ENFORCEMENT ACTION AGAINST	§	BEFORE THE
LIH WURZBACH MANOR, LP	§	TEXAS DEPARTMENT OF
WITH RESPECT TO	§	HOUSING AND COMMUNITY
WURZBACH MANOR APARTMENTS	§	AFFAIRS
(HTC FILE # 19413 / CMTS # 3277)	§

**AGREED FINAL ORDER**

## **Exhibit 1**

### **Instructions to Correct Final Construction Inspection Violations**

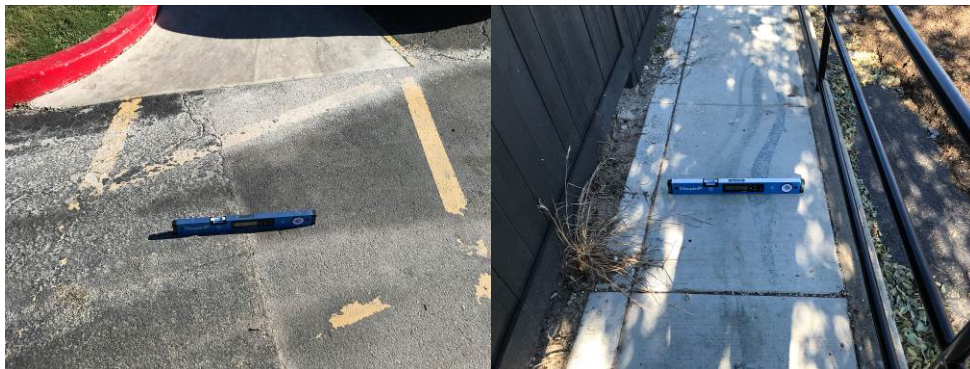
**Item #3 Deficiency: Accessible Building and Facility Entrance (2010 ADA 206.4)** The primary entrance to mobility accessible unit 4246B is subject to ADA design requirements. The route to the entrance has steps with no ramp or lift and is not connected with the accessible route for the property. Additionally, the route that exits on the property to the public street is not an acceptable alternate to the general circulation path.

- **Corrective Action** – Please provide an architect’s or accessibility specialist’s certification with photographic evidence certifying the condition has been corrected at the cited unit and all mobility units. The certification must verify that a dedicated no-step pedestrian route that coincides with or is located in the same area as general circulation paths and is an interior route if the general circulation path is interior connects to the entrances of all common use facilities; employee use work areas; and mobility accessible dwelling units.

Provide a site plan showing the accessible route connecting all accessible parking spaces, mobility accessible units, and public and common use facilities. Indicate on the site plan the locations of all curb-cuts, ramps, handrails, stairs/steps, and overhead hazard cane detection barriers.

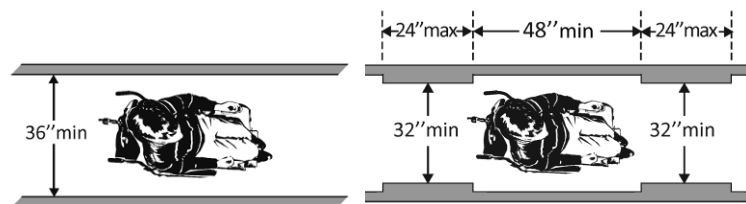
**Item #5 Deficiency: Accessible Route Width (2010 ADA 403.5.1-403.5.3)** This development is subject to ADA design requirements. The pedestrian route near the community center is the only commonly used circulation route to the common use mail kiosk and is required to be an accessible route, however, it does not meet the minimum width requirement for an accessible route. An overhanging bush encroaches on the route width. Additionally, the pedestrian route between the public sidewalk and leasing office is required to be an accessible route, however, it does not meet the minimum width requirement for an accessible route. Overhanging vehicle bumpers encroach on the route width.

- **Corrective Action** – Please provide an architect’s or accessibility specialist’s certification with photographic evidence that the condition has been corrected at the location cited and throughout the accessible route for the property. The certification must verify that the entire route provides a minimum width of 36 inches. Note that route width is permitted to be reduced to 32 inches for short segments of the route no greater than 24 inches long, and where multiple reduced-width segments are separated by segments that are at least 48 inches long and at least 36 inches wide (see illustration)

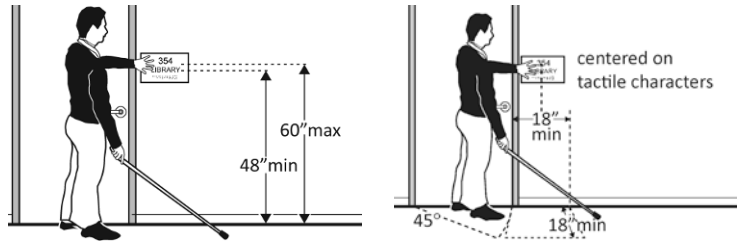
**Item #10 Deficiency:** Room and Egress Route Signage (2010 ADA 216.2, 216.4.1, 703) This development is subject to ADA design requirements. The signs at doors identifying permanent rooms and spaces (leasing office unisex restroom) do not meet the *tactile* and *visual* character requirements for accessible signage.

- **Corrective Action** – Please provide an architect’s or accessibility specialist’s certification with photographic evidence that the condition has been corrected at the location cited and throughout the property. The certification must verify that all room and space signage, including egress route signs, and excluding exterior room and space signs not located at a door, meets the technical specifications required under ADA 703, and specifically verifies the following conditions are provided: 1) a non-glare finish with text characters on a high-contrast background (light on dark or dark on light); 2) all room and egress route signs provide *tactile* text characters meeting ADA 703.2 and braille meeting ADA specifications 703.3 and installation height and location meeting ADA 703.4; 3) all room and egress route signs also provide *visual* text characters meeting ADA 703.5; 4) for any signs designating exterior rooms and spaces not located at a door and not accompanied by braille, text characters are *visual* meeting ADA 703.5; and 5) any egress route signs meet all local codes and ordinances.

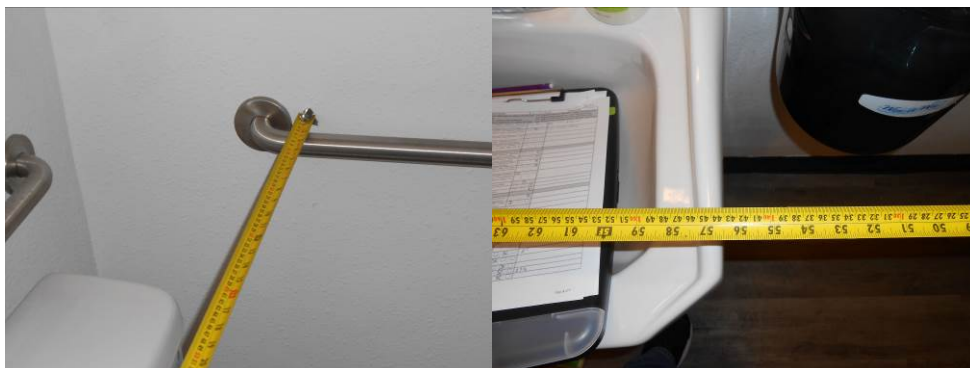
**Item #19 Deficiency:** Laundry Machines (TDHCA/2010 ADA 214, 611) The laundry room at the community center is identified as a common use facility serving accessible dwelling units and subject to TDHCA/ADA design requirements. The laundry room does not provide an accessible front-loading washing machine.

- **Corrective Action** – Provide an architect’s or accessibility specialist’s certification with photographic evidence that the laundry machines at this location have been corrected or are already correct. The certification must verify that applicable laundry rooms and accessible laundry machines are on an accessible route, and that at least one front-loading washer and dryer is provided in each accessible laundry room, and that the clear floor space at each accessible machine is positioned for a side (parallel) approach, and is centered on the machine with no obstruction within 24 inches on either side of the centerline, with unobstructed controls and operable parts at 15-48 inches above the floor.

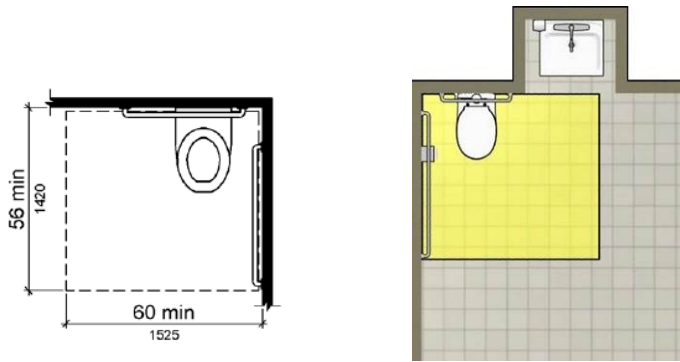
**Item #21 Deficiency: Toilet Clear Floor Space (2010 ADA 604.3)** The leasing office and community center are identified as common use facilities and subject to ADA design requirements. The accessible toilet in the unisex (leasing office), men's (community center), and women's (community center) restrooms do not provide an unobstructed clear floor space of the required dimensions. An overlapping lavatory cabinet is located within the required clear floor space.

- **Corrective Action:** Please provide an architect's or accessibility specialist's certification with photographic evidence that the condition has been corrected in all common use restrooms having these conditions. The certification must verify that the width of the clear floor space is at least 60 inches (side to side) and the depth is at least 56 inches (front to back). Note that only grab bars, dispensers, sanitary napkin disposal units, coat hooks, shelves, accessible routes, clear floor space required at other fixtures, and the turning space are permitted to overlap. Ensure that no other fixtures or obstructions are located within the required toilet clearance.

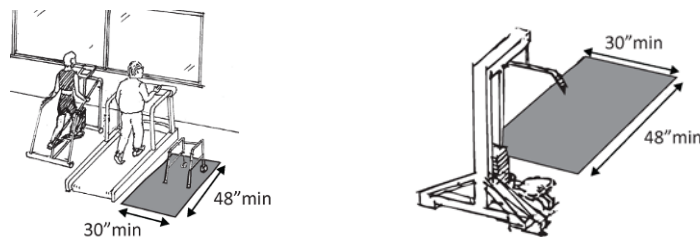
**Item #28 Deficiency:** Exercise Machines Access (2010 ADA 236, 1004.1) The community center is identified as a common use facility and subject to ADA design requirements. The workout facility in the community center does not provide a clear floor space for access to at least one of each type of exercise machine that is located on an accessible route.

- **Corrective Action** – Please provide an owner’s certification with photographic evidence that the condition has been corrected. The certification must verify that a 30 inch x 48 inch clear floor space is provided for transfer or for use by an individual seated in a wheelchair requiring either a parallel or forward approach to at least one of each type of exercise machine.

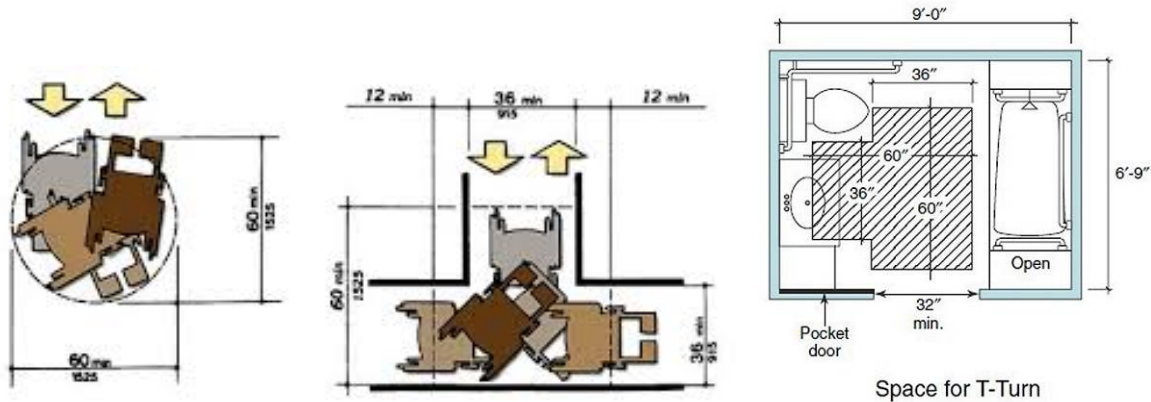
**Item #33 Deficiency: Turning Space (2010 ADA 304.3, 809.2.2)** Units 4311B and 4246B are designated as mobility accessible dwelling unit and subject to ADA design requirements. In dwelling units, a turning space is required in all rooms on an accessible route, including the non-complying bathroom. The turning space required for a user to make an 180° turn in the master bathroom does not provide a 60 inch diameter circle or a T-shaped turning space. Additional mobility accessible dwelling units were not inspected but may also be affected.

- **Corrective Action** – Please provide an architect’s or accessibility specialist’s certification with photographic evidence that the condition has been corrected in the cited unit and all other mobility accessible dwelling units. The certification must verify that a turning space is provided in the master bathroom that meets the following conditions: 1) allows the user to make a 180° turn with a minimum 60 inch diameter circle, or a T-shaped space with unobstructed 36 inch wide and 12 inch deep arms, and minimum 36 inch wide and 24 inch deep base of T; 2) has a surface that is firm, stable and slip resistant, with no abrupt level changes; 3) has a surface slope no greater than 2% (1:48); and 4) adjoins or overlaps an accessible route.

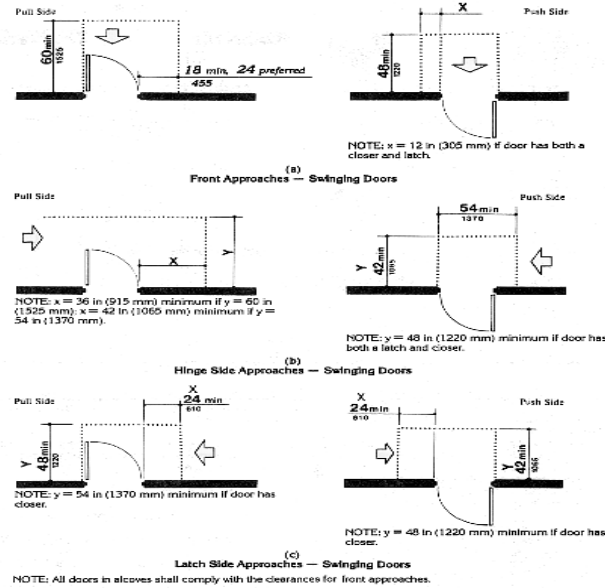
**Item #35 Deficiency: Door Clear Opening (2010 ADA 404.2.3)** In this rehabilitation development, units 4311B and 4246B are designated as a mobility accessible dwelling unit and subject to ADA design requirements. The master bathroom door does not provide the minimum clear opening for a passage door on an accessible route. The clear opening with the door open 90° was 21½ inches. Additional mobility accessible dwelling units were not inspected but may also be affected.

- **Corrective Action** – Provide an architect’s or accessibility specialist’s certification with photographic evidence (one sample photo only) that the door in the cited unit and that all passage doors in all other mobility accessible dwelling units provide at least a 32 inch clear opening width measured from the face of the door when door is opened to 90° to the door stop on the opposite jamb.

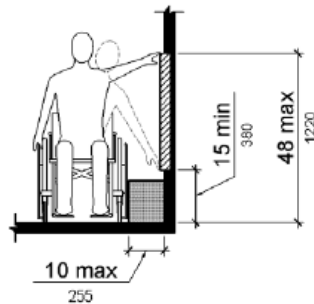
**Item #37 Deficiency:** Operable Parts (2010 ADA 205, 308-9) Units 4363B, 4334B, 4311B, and 4246B are identified as mobility accessible dwelling units and subject to ADA design requirements. The bathroom pocket door hardware requires tight grasping, pinching, or twisting of the wrist. Additional mobility accessible dwelling units were not inspected but may also be affected.

- **Corrective Action** – Provide an architect’s or accessibility specialist’s certification with photographic evidence that the bathroom pocket door hardware at the cited unit and all other mobility accessible dwelling units have been corrected or are already correct. The certification must verify that accessible pocket door hardware does not require tight grasping, pinching, twisting of the wrist, and is on an accessible route, and, where the clear floor space is positioned for an unobstructed side (parallel) approach, the height of the pocket door hardware is 15-48 inches above the floor (an object that is less than or equal to 34 inches high and less than or equal to 10 inches deep is not considered an obstruction).

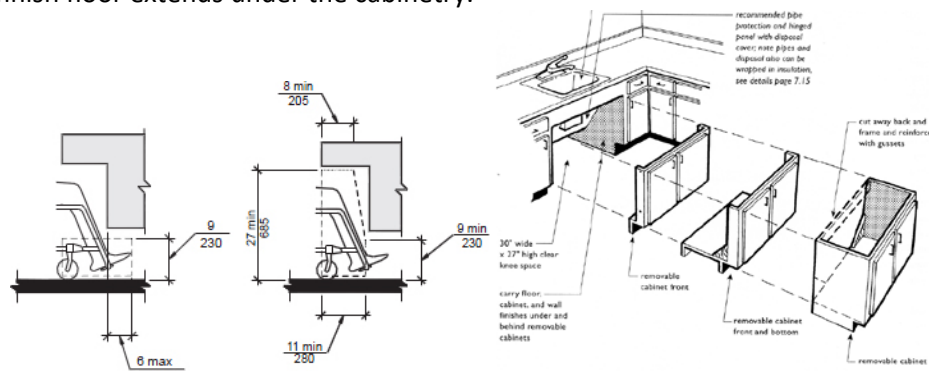
**Item #39 Deficiency:** Work Counter (2010 ADA 804.3, 804.6.5) Unit 4246B is designated as a mobility accessible dwelling unit and subject to ADA design requirements. The kitchen does not provide an accessible work counter with a minimum 30” wide accessible open knee space or removable cabinet beneath. Additional mobility accessible dwelling units were not inspected but may also be affected.

- **Corrective Action** – Provide an architect’s or accessibility specialist’s certification with photographic evidence that the condition has been corrected in the cited unit and all other mobility accessible dwelling units. The certification must verify that all accessible work counters meet the following conditions: 1) the counter height is no more than 34 inches above the floor; 2) an unobstructed 30 inch by 48 inch floor space is positioned to provide a forward (perpendicular) approach, with the 48 inch dimension measured from a point under the counter that is no more than 19 inches back from the front edge of the counter; 3) the work surface is positioned adjacent to one side of the bottom-hinged oven; 4) the minimum clearance beneath the counter is: (a) knee space is 8 inches deep (measured horizontally from the front edge of the counter) at a point that is 27 inches above the floor; (b) leg clearance is 11 inches deep at a point 9 inches high; and (c) toe clearance is at least 17 inches deep at a point at least 9 inches high; 5) any base cabinetry that conceals the knee, leg, and toe clearance below the counter is quickly and easily removable without removal or replacement of the counter or surrounding structure, the walls behind and surrounding the cabinetry are finished, and the finish floor extends under the cabinetry.

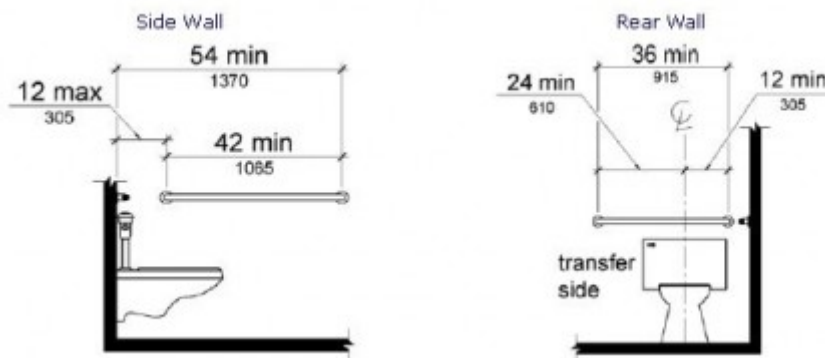
**Item #41 Deficiency: Mirror Height (2010 ADA 603.3)** Units 4363B, 4334B, 4311B, and 4246B are designated as mobility accessible dwelling units and subject to ADA design requirements. The mirror above the lavatory in the accessible bathroom was measured at more than 40 inches above the floor. Additionally, the medicine cabinet mirror not above the lavatory in the accessible bathroom was measured at more than 35 inches above the floor. Additional mobility accessible dwelling units were not inspected but may also be affected.

- **Corrective Action** – Please provide an architect’s or accessibility specialist’s certification with photographic evidence that the condition has been corrected in the cited unit and all other mobility accessible dwelling units. The certification must verify that bathroom mirrors at accessible lavatories are positioned with the bottom edge of the reflecting surface no higher than 40 inches above the floor or mirrors not located above lavatories are positioned with the bottom edge of the reflecting surface 35 inches maximum above the floor. Where mirrors are provided, at least one shall comply with 603.3.

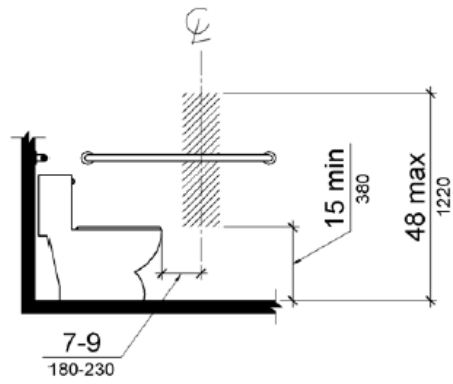
**Item #43 Deficiency: Toilet Paper Dispensers (2010 ADA 604.7)** Units 4363B, 4311B, and 4246B are designated as mobility accessible dwelling units and subject to ADA design requirements. The toilet paper dispenser in the accessible bathroom is not installed in an accessible location relative to the toilet. The centerline of the dispenser was not located between 7 and 9 inches from the front of the toilet. Additional mobility accessible dwelling units were not inspected but may also be affected.

- **Corrective Action** – Please provide an architect’s or accessibility specialist’s certification with photographic evidence that the condition has been corrected in the cited unit and all other mobility accessible dwelling units. The certification must verify that the toilet paper dispenser in all accessible bathrooms meets the following conditions: 1) does not control delivery or prevent

continuous paper flow; 2) centerline is located between 7 and 9 inches in front of the toilet bowl; 3) outlet is between 15 and 48 inches above the floor; and 4) is no less than 1½ inches to the bottom and no less than 12 inches to the top of the grab bar.
